PLANT NAME: St. Lucie Unit 1

Re: St. Lucie Unit No. 1 (Docket 50-335)
Conditions of License

REACTOR CONTAINMENT FAN COOLER MOTOR
GENERAL DESIGN PHILOSOPHY

WCAP 7829, Rev. 6-30-76

Additionally, Figures 1, 2, and 3 show the air flow pattern through the motor and heat exchanger indicating the heat exchanger inlet and exhaust temperatures for normal (Figure 1), DBE (Figure 2), and Post DBE (Figure 3) operation.

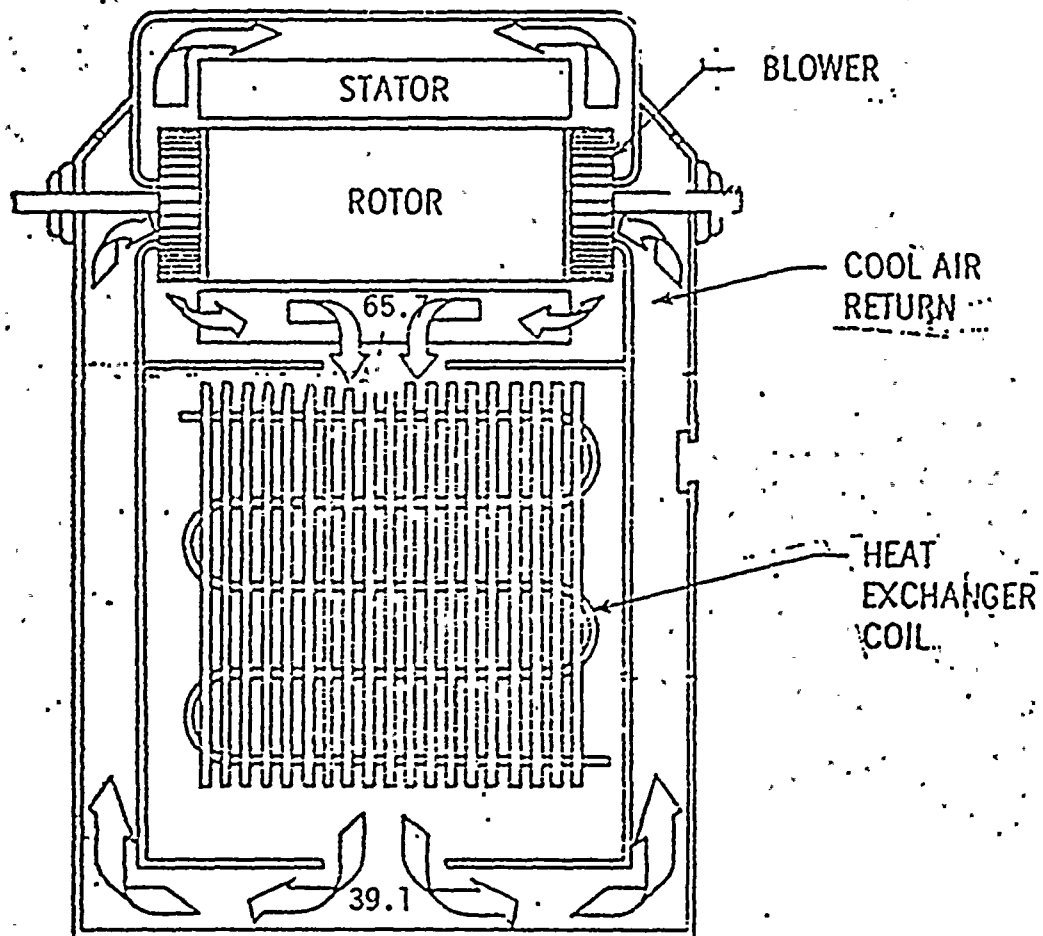
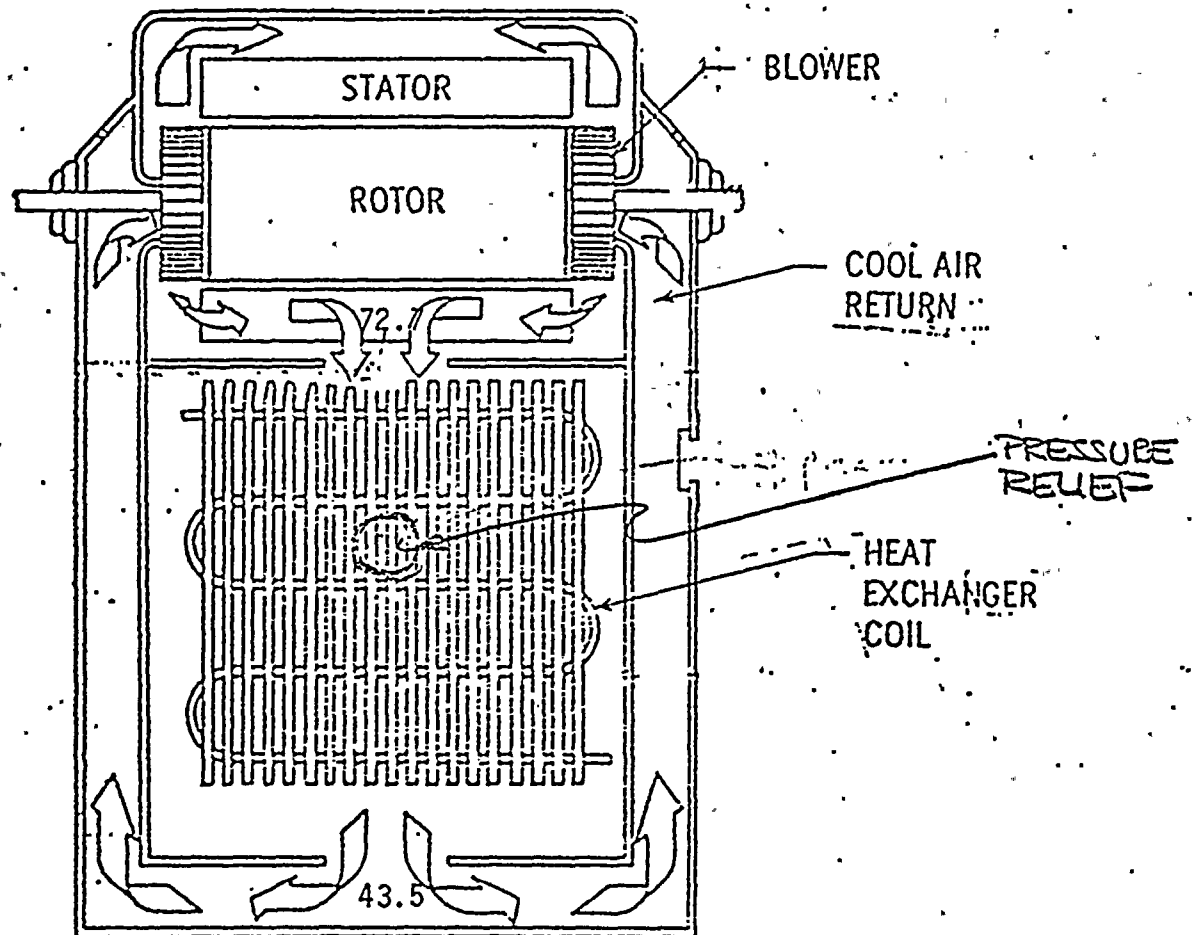
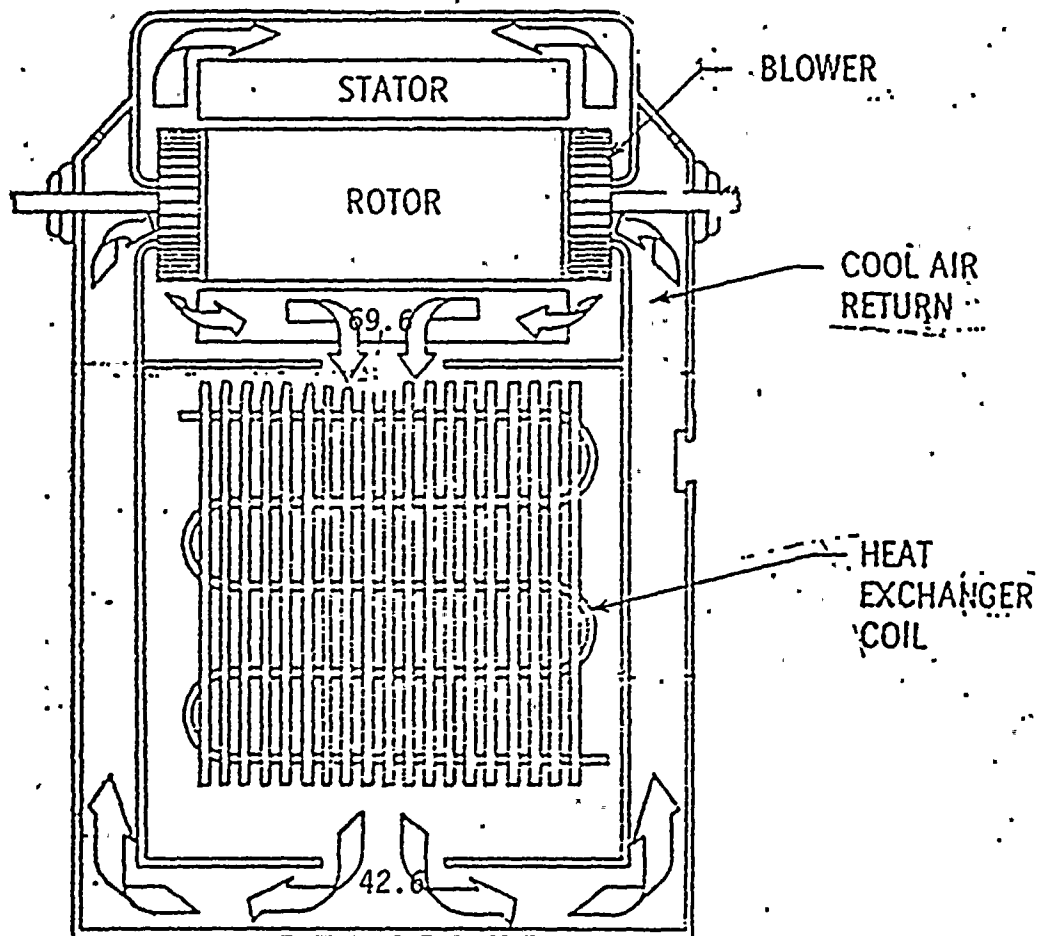
3. A letter from J. Irons of June 14, 1976, states that the table "Typical Motor Design Parameters Compared to Test Machine" shows an insulation peak temperature of 105.8°C for worst case DBA conditions. Heat which must be removed from PSL-1 fan cooler motor windings is 1.) added heat from outside DBA conditions 2) added heat generated internal to winding due to fan cooler load. The motor in WCAP 7829 demonstrates only that the heat from outside DBA conditions plus the heat resulting from current of 26.1 Amps can be removed by the heat exchanger. Provide results of heat exchanger analysis to demonstrate the PSL-1 motor insulation temperature W.71 remain within 105.8°C for worst case DBA conditions plus full load current of 200 amperes.

Due to the number of variables for each plant (i.e. cooling water temperatures, containment temperatures, motor losses, etc.) the heat exchanger must be specifically sized for its particular application. This is accomplished by use of a computer code developed for this purpose.

Copies of the computer print out for the heat exchangers used in the St. Lucie motors are listed as Item 1 thru 6. Items 1 and 2 are for normal operation, 3 and 4 for DBE operation and 5 and 6 for post DBE operation.

Performance of the heat exchanger is predicted by a computer program. It has been verified by standard ARI coil certification tests. Heat and mass transfer occurring on the surface of base enclosure and motor are based on standard correlation for free convection heat transfer and "COLBURN ANALOGY" between heat and mass transfer. Heat transfer of the interior of base enclosure is based on the standard "COLBURN RELATIONSHIP" for turbulent forced convection in an enclosed space.

Heat transfer between the outside of the motor frame and air passing through the motor is based on a computer program developed to predict the heat transfer performance for electric motors of this type. The attached print outs are computer out put for normal and POST LOCA operation of heat exchanger for PSL-1. It should be noted that the heat exchanger is suitable for the worst environment of DBA condition, (Items 3 and 4), which includes the maximum heat losses of the motor associated with its increased horsepower requirements during DBA operation. Under normal and POST DBA operation, performance of the heat exchanger greatly exceeds the heat removal requirements.
